Interactive comment on “The Interactions between Soil-Biosphere-Atmosphere (ISBA) land surface model Multi-Energy Balance (MEB) option in SURFEX – Part 2: Model evaluation for local scale forest sites” by Adrien Napoly et al.

Received and published: 3 March 2017

Fig. 1.

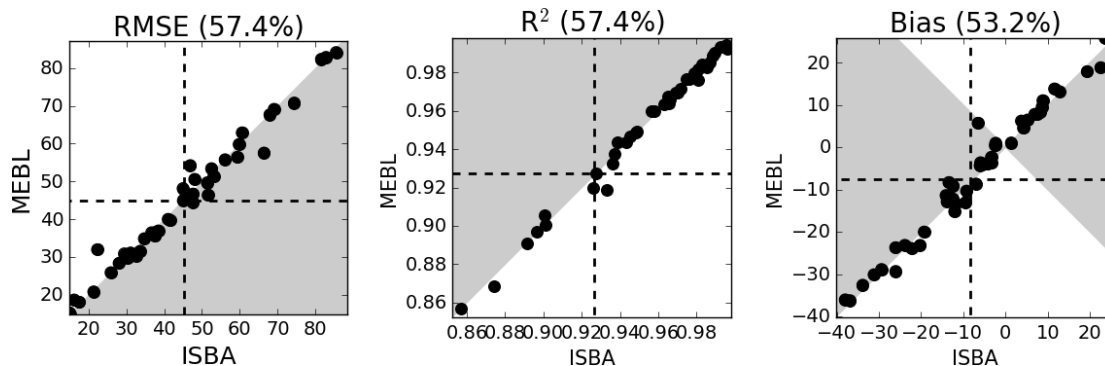
Comment : P 16. Can you also include a figure for Rnet comparison?

Answer : Please find attached the figure named fig2.png for an Rn comparison. However, we think that this figure does not add much since there are mostly minor differences between the two models. The main information in fig2.png is that the average over all sites is slightly biased and that RMSE is higher, compared to the three local sites (due to more uncertainties in albedo, LAI . . .) : this is already explained in the text. We can add this figure, but since we feel it does not add alot of additional information and since the paper already includes a lot of figures, we can let this reviewer the editor decide.

Fig. 2.

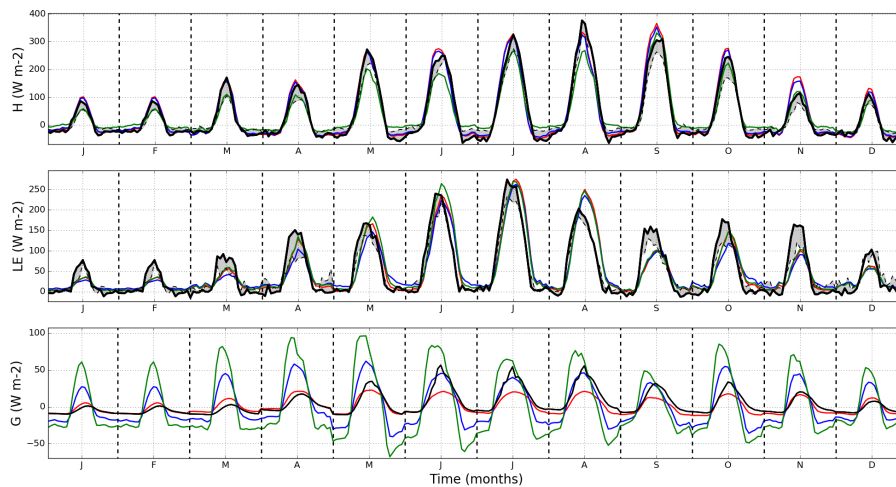
Comment : Section 5.3: In world wide assessment, is it possible to report also the results with MEB? It would be interesting for readers to see how including litter layer will affect the results.

Answer : We plot on fig5.png the results for RMSE calculations for H (left panel) and

LE (right panel). It shows that the litter option almost always performed better for both H and LE. We chose not to show this result mainly for 2 reasons: first, because the paper already includes many figures and we have tried to include those that are the most essential, and second, because the first part of the validation already showed the necessity of the litter representation so that the litter option can be considered for forest as the default version. That being said, if this reviewer think that it is necessary, we propose to add this figure (fig5.png) in the appendix. We propose to refer to it in the text (if it is added) by adding the text: “ As mentioned in Section 5.1, significant improvement is obtained with MEB compared to ISBA, and even more improvement with MEBL. An example of the improvement in H and LE between MEB and MEBL is shown in Appendix C Fig.16. But because of the consistently best behavior with MEBL verses ISBA compared to MEB, MEBL has become the default option for forests.”

Fig. 3.

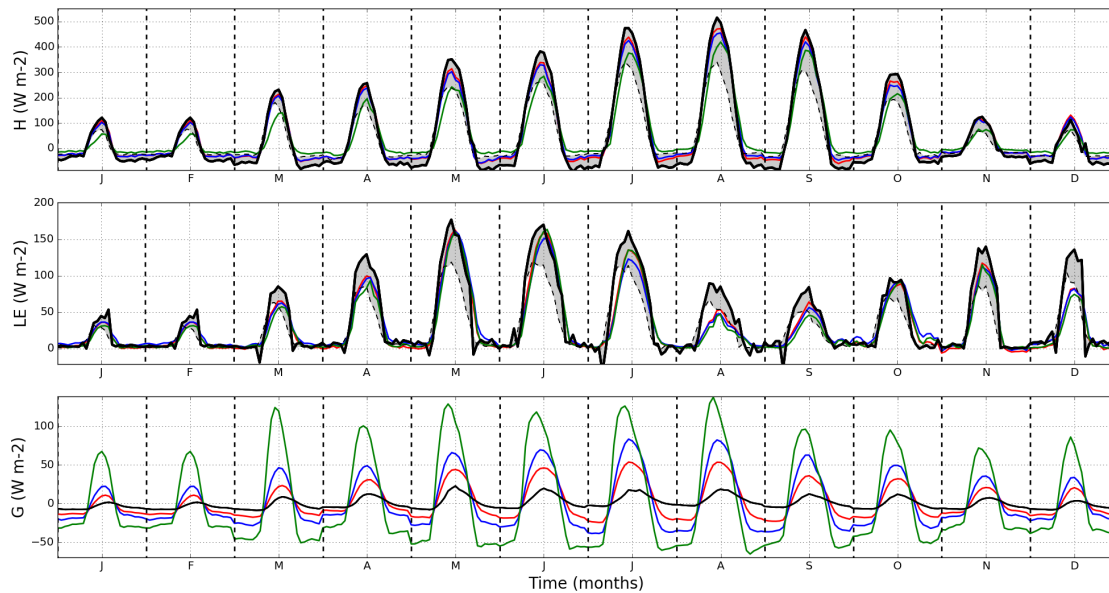
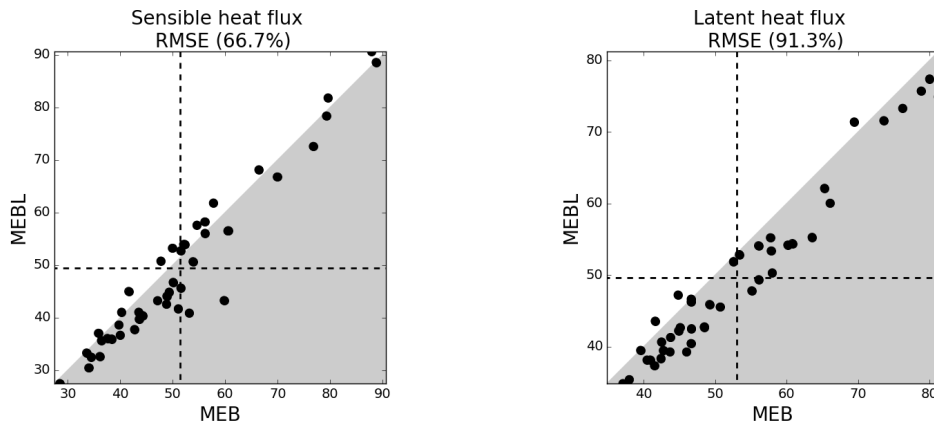
Comment : Figures 4b and 5b: Hard to see the lines. Can you possible change the scale of the yaxis ? also add the units in on Y-axis. Shaded are is not shown well in the figures.

Answer : We have plotted both turbulent flux components with the same scale so as the reader can easily understand that the energy from the G mostly goes into H. fig3.png and fig4.png shows figures 4 and 5 of the paper, respectively, with changes to the yaxis

scale. We think that the new figure could bias the reader in terms of the relative weigh of H and LE and that it doesn't add much information since the LE fluxes are quite similar between the models.
